# HISTORIC AND DESIGN REVIEW COMMISSION

Agenda Item No: 10

**HDRC CASE NO:** 2016-186  
**ADDRESS:** 426 ADAMS ST  
**LEGAL DESCRIPTION:** NCB 2879 (DIAZ SUBDIVISION), BLOCK 004 LOT 19  
**ZONING:** RM4 H  
**CITY COUNCIL DIST.:** 1  
**DISTRICT:** King William Historic District  
**APPLICANT:** Harrison & Billie Jo Gutierrez  
**OWNER:** Harrison & Billie Jo Gutierrez  
**TYPE OF WORK:** Driveway installation  
**REQUEST:**

The applicant is requesting a Certificate of Appropriateness for approval to install a concrete driveway at 426 Adams.

# Current Proposal

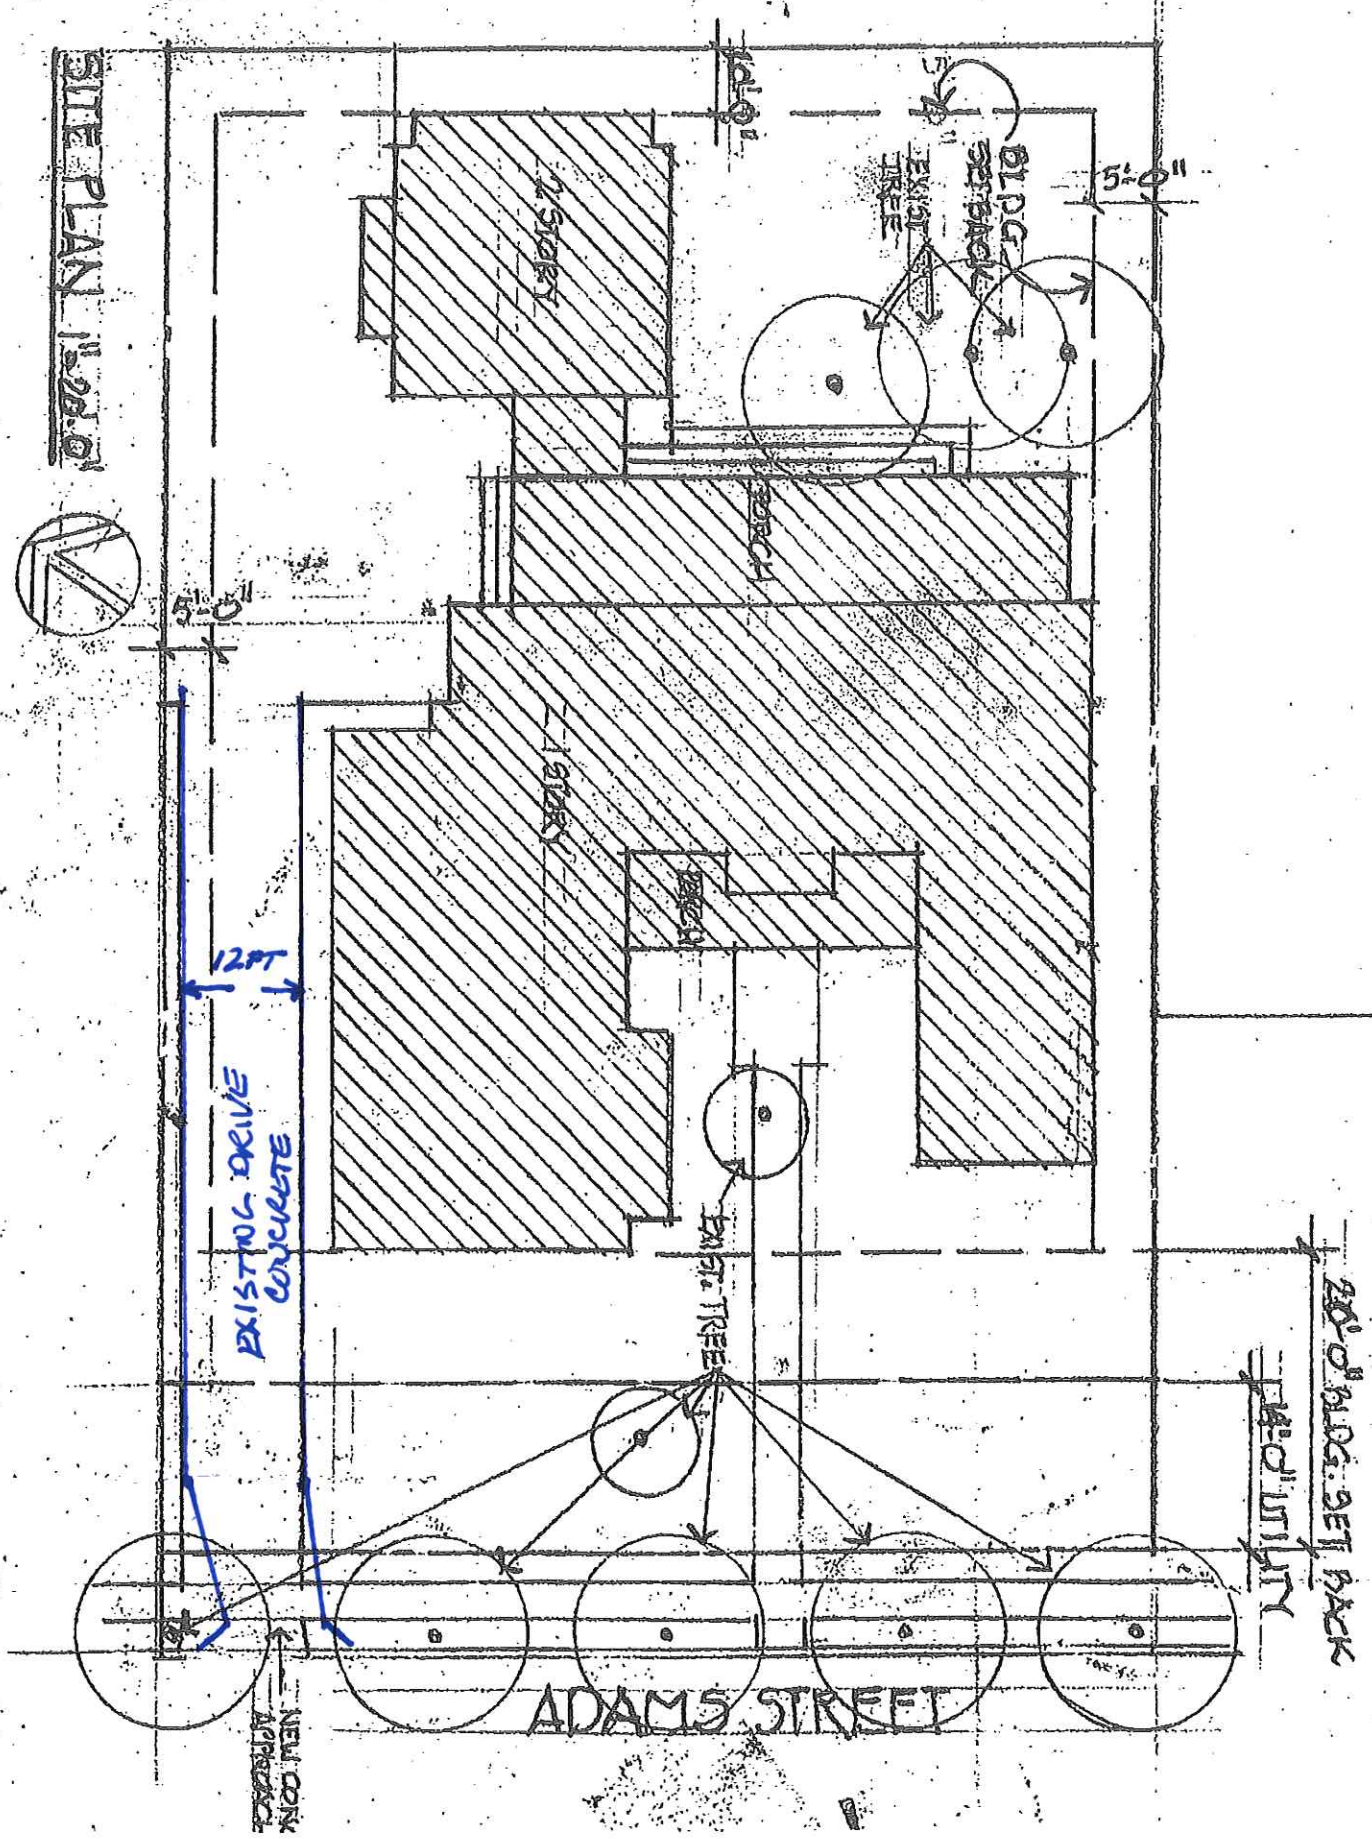
- c. According to the Guidelines for Site Elements, 5.B.i., the materials, width and design of driveways should be similar to those found throughout the neighborhood or those previously on the site. Staff finds that generally, the applicant's proposed materials and width are appropriate.

- d. Historic driveways throughout the King William Historic District feature materials consisting of concrete, crushed gravel, decomposed granite and brick pavers all of which contain various textures and colors. Staff finds the applicant's use of dye to reduce the overall brightness of the concrete appropriate.

- e. In regards to the design of the proposed driveway, staff recommends the applicant modify the angled driveway to feature slight curves. Curved driveways are found throughout the King William Historic District in historic contexts. Staff recommends the applicant provide a new site plan noting the curved driveway as recommended by staff.

Staff recommends approval based on findings a through e with the stipulation that the applicant the applicant pour a curved driveway as noted in finding e. Staff recommends the applicant provide a new site plan noting the curved driveway as recommended by staff.

# Current Proposal

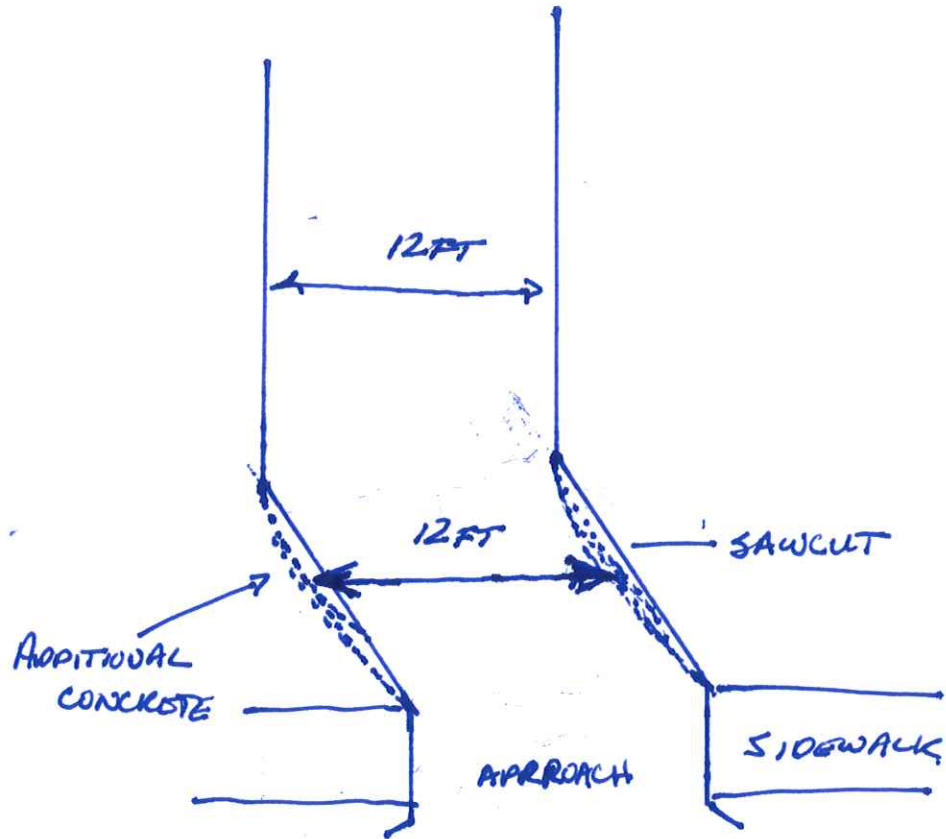
- b. Since the time of the issuance of the administrative Certificate of Appropriateness, a concrete driveway has been installed that is not consistent with the approved design. The Historic Building Enforcement Officer visited the site on May 9, 2016, and documented the completed concrete driveway which features an angled approach to the curb cut. The applicant has noted that an existing utility pole prevented the installation of a straight driveway.
